ADDENDUM NUMBER: One (1)

DATE: November 12, 2025

PROJECT: MONTGOMERY COUNTY EMS STATION 28

DESIGNER: DOUGLAS A. JONES, ARCHITECT
MONTGOMERY COUNTY ENGINEERING

C8.4

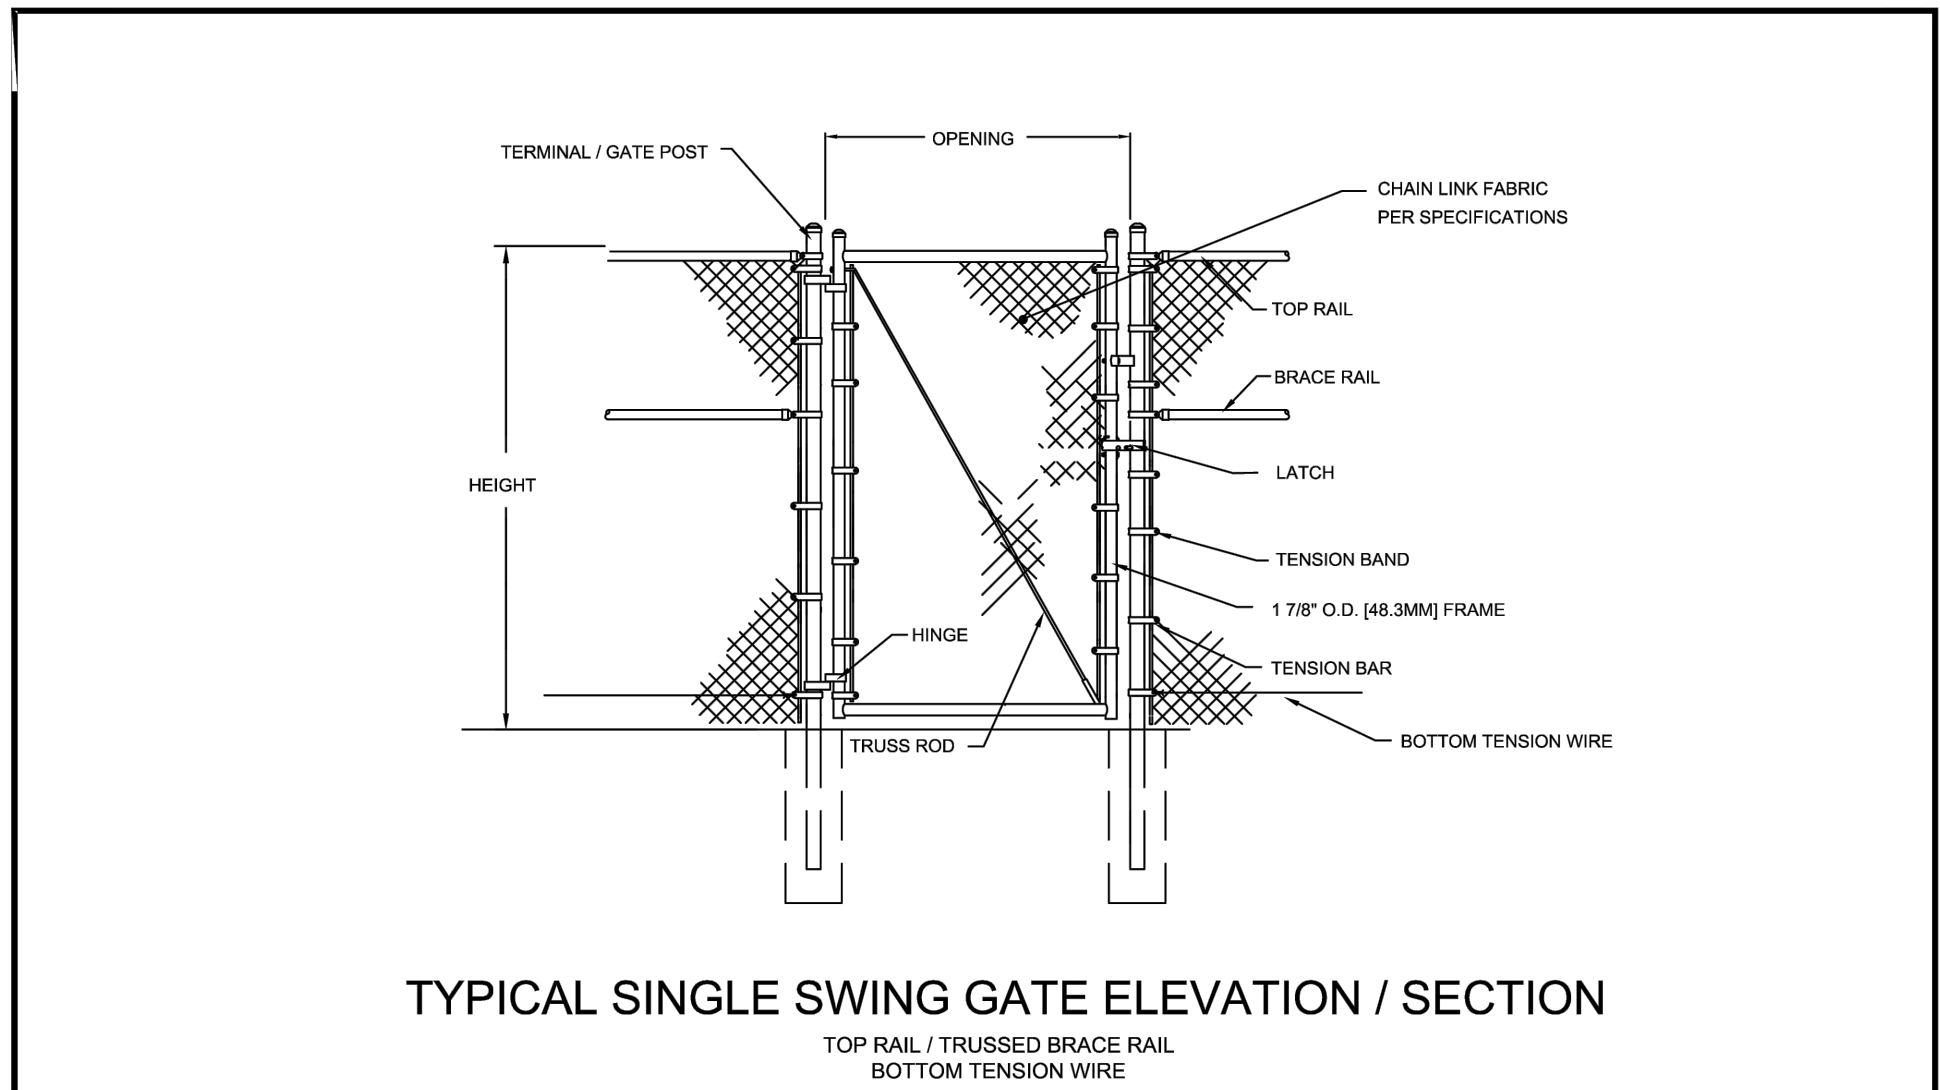
SHEET C8.4 - GENERAL SITE DETAILS; Delete Sheet C8.4 dated 11/03/2025 in its entirety. Substitute therefor: Sheet C8.4 - GENERAL SITE DETAILS dated 11/12/2025 attached hereto.

Clarification: Manhole Detail was added.

RIP-RAP APRON
NO SCALE

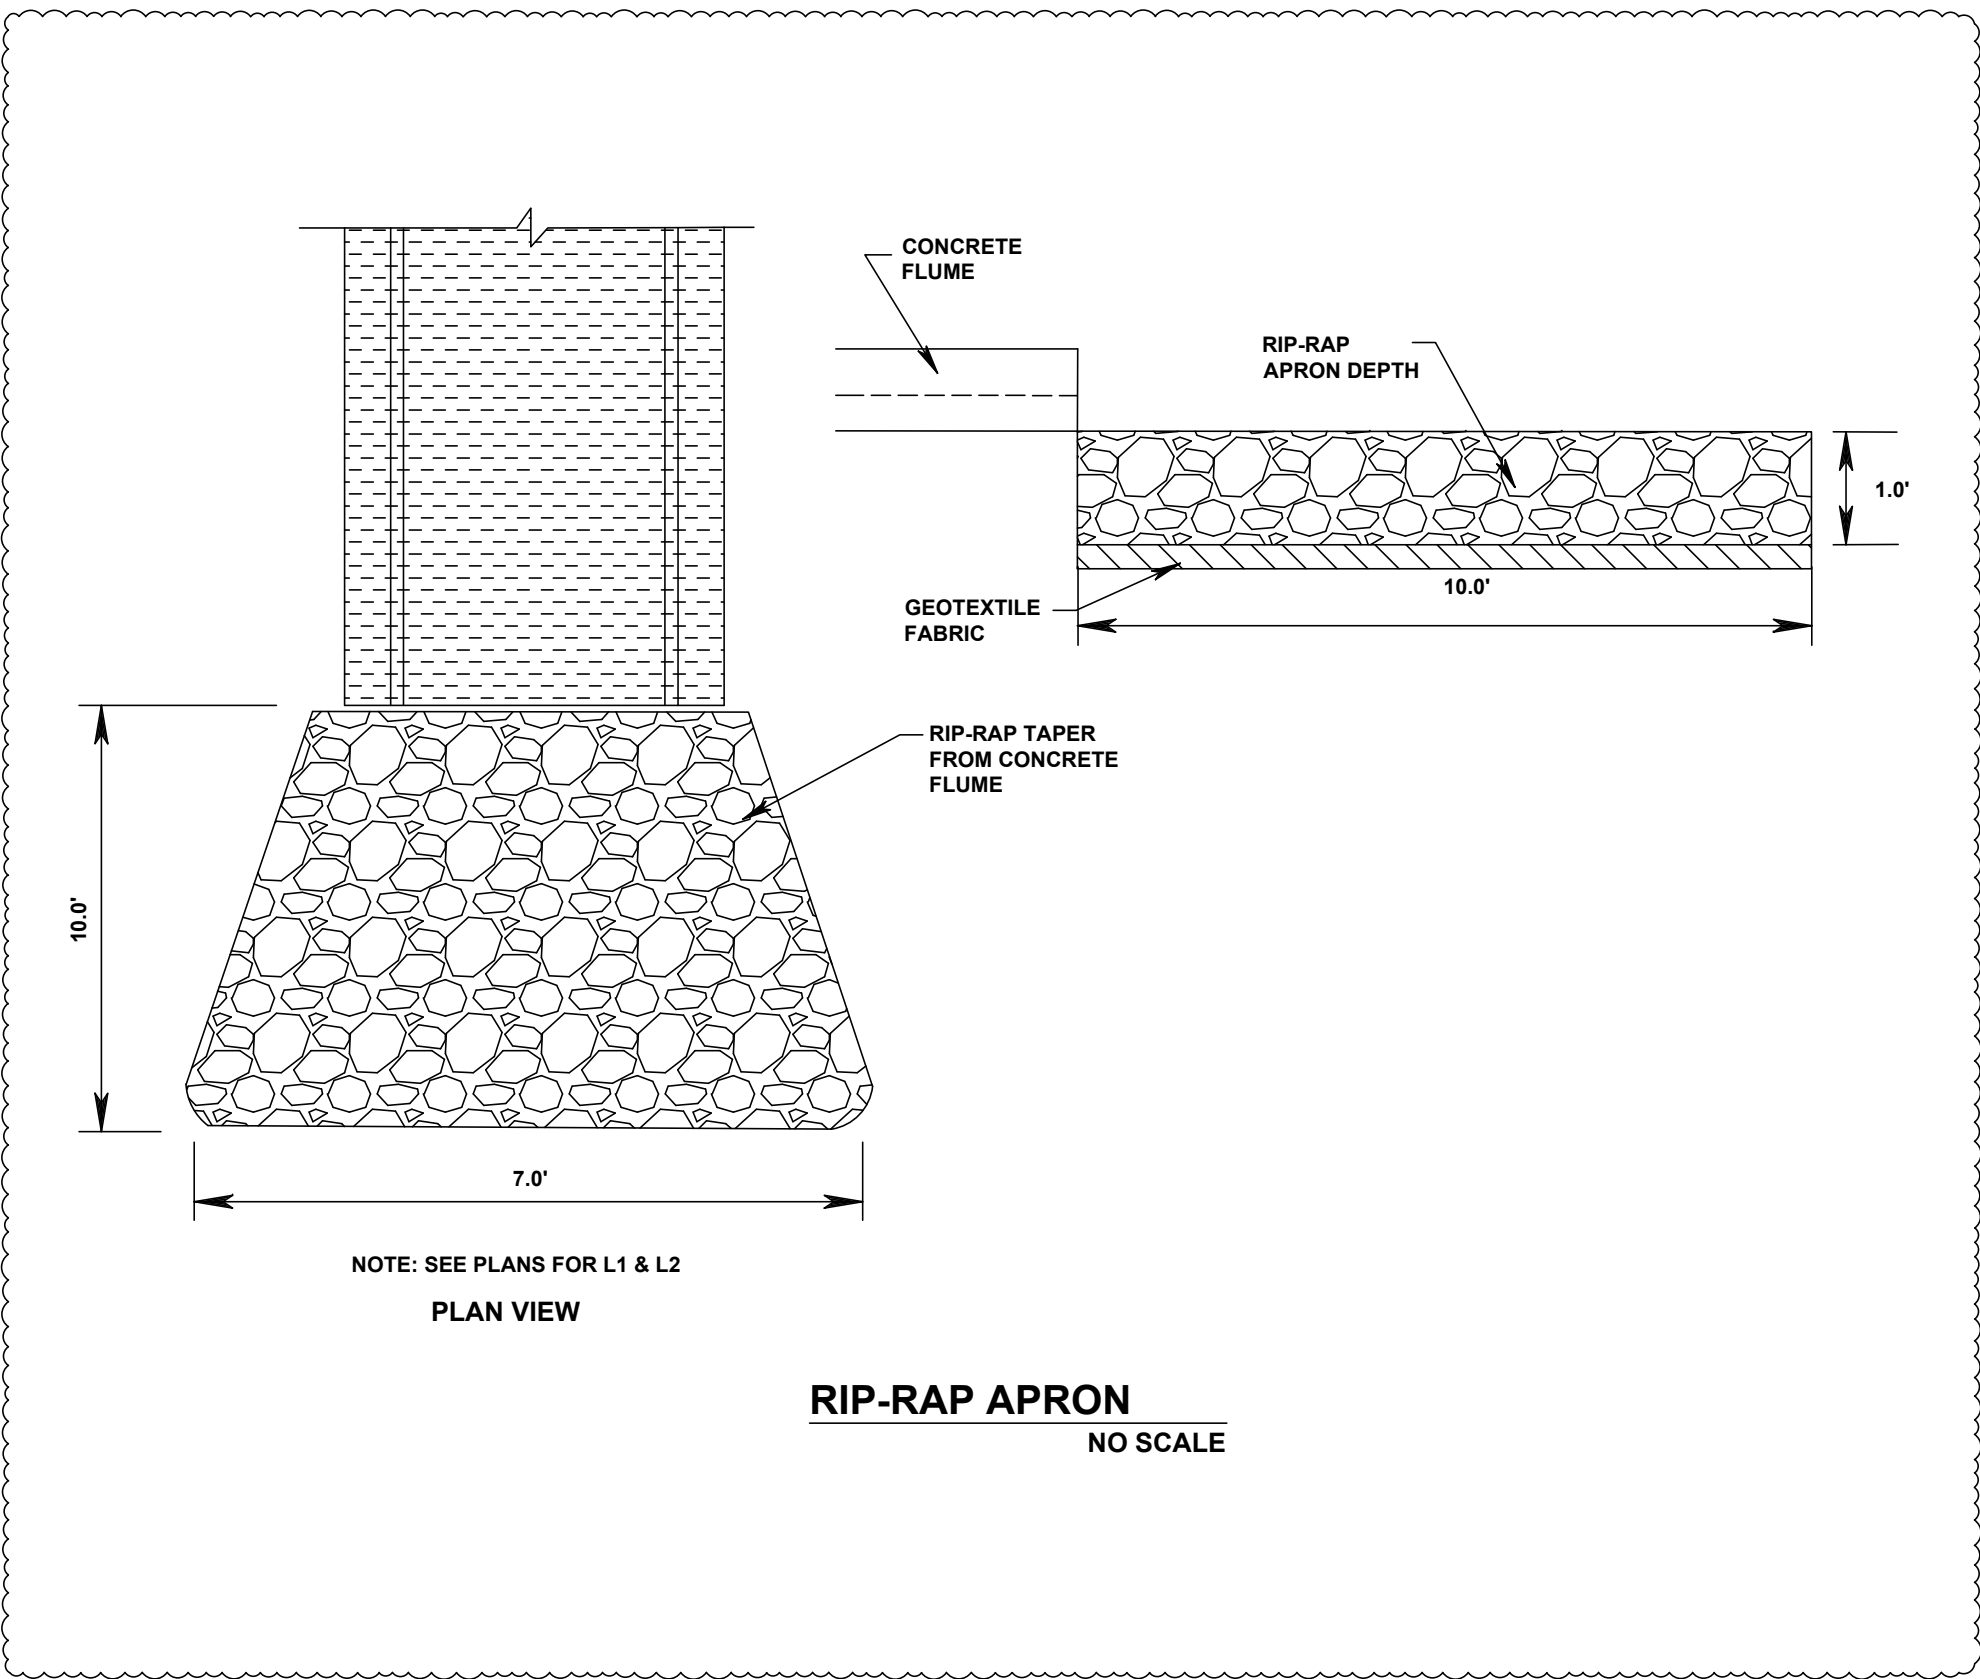
SHEET C8.6 - GENERAL SITE DETAILS; Delete Sheet C8.6 dated 11/03/2025 in its entirety. Substitute therefor: Sheet C8.6 - GENERAL SITE DETAILS dated 11/12/2025 attached hereto.

Clarification: Relocated Rip Rap Detail from sheet C8.3.

M1.1

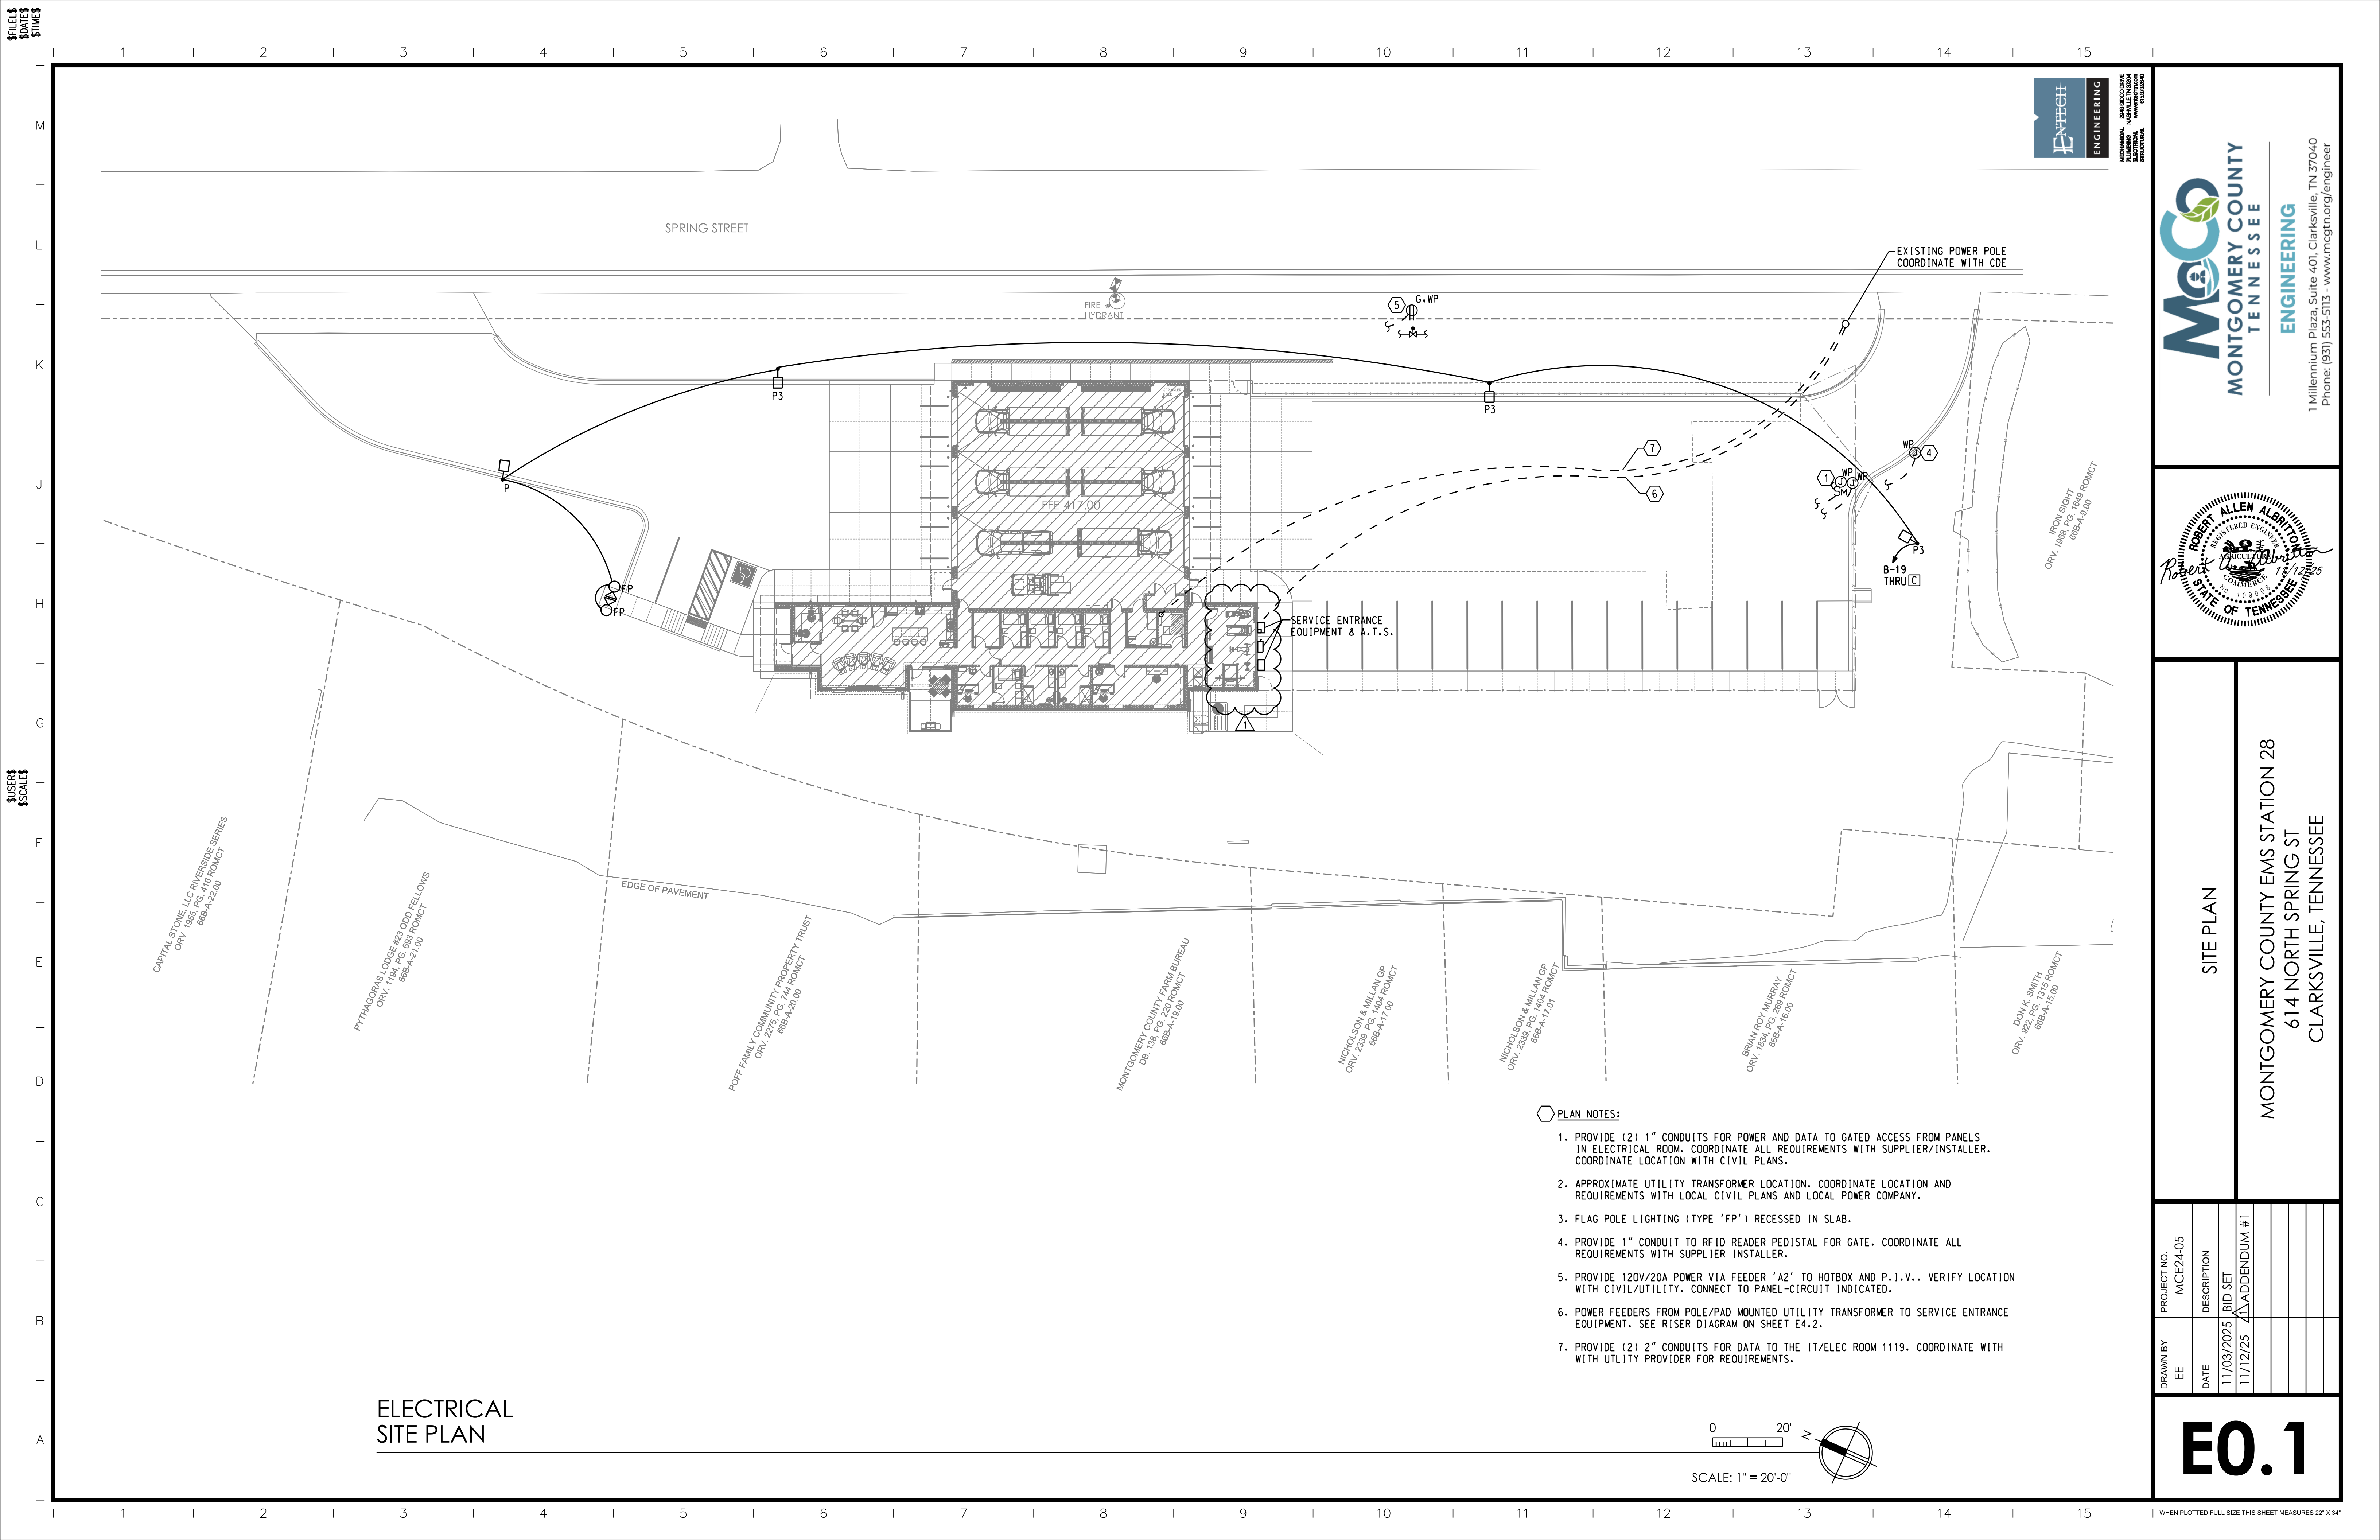
SHEET M1.1 - HVAC LEGENDS & SCHEDULES; Delete Sheet M1.1 dated 11/03/2025 in its entirety. Substitute therefor: Sheet M1.1 - HVAC LEGENDS & SCHEDULES dated 11/12/2025 attached hereto.

Clarification: Additional acceptable manufacturers added to HVLS Fan SCHEDULE & Exhaust Fan Schedules.

- Q:** Closet 121 - what is the light in this room?
- A:** Type 'C' fixture will be used in this room. See revised sheet E1.0.
- Q:** Who will supply the big fan in the bay? if electrical Will we need info on what is to be supplied.

- A:** The Fan is scheduled on the HVLS Fan Schedule on Sheet M1.1 - HVAC LEGENDS & SCHEDULES and Called out on Sheet M2.1 - HVAC FLOOR PLAN. Sheet M1.1 has been revised to add additional acceptable manufacturers. Refer to Item No. 11 above.
